10/555,921

REMARKS

Fig 6.

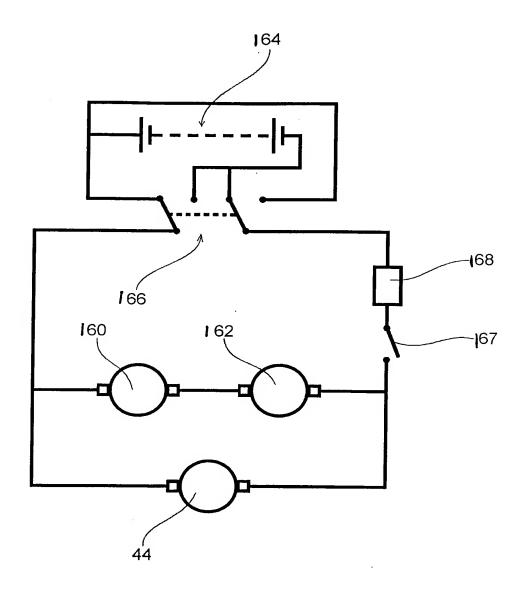
Fig. 6 of the drawings is amended, per the attached, to overcome a few noted informalities contained therein. The accompanying new Replacement Sheet of formal drawing incorporates all of the requested drawing amendments. If any further amendment to any of the drawings is believed necessary, the Examiner is invited to contact the undersigned representative of the Applicant to discuss the same.

The above amended paragraph of the specification is amended to now be consistent with the above entered amendments to Fig. 6. The undersigned avers that none of the above amendments to paragraph [034] of the specification nor the amendments to Fig. 6 contain any new subject matter.
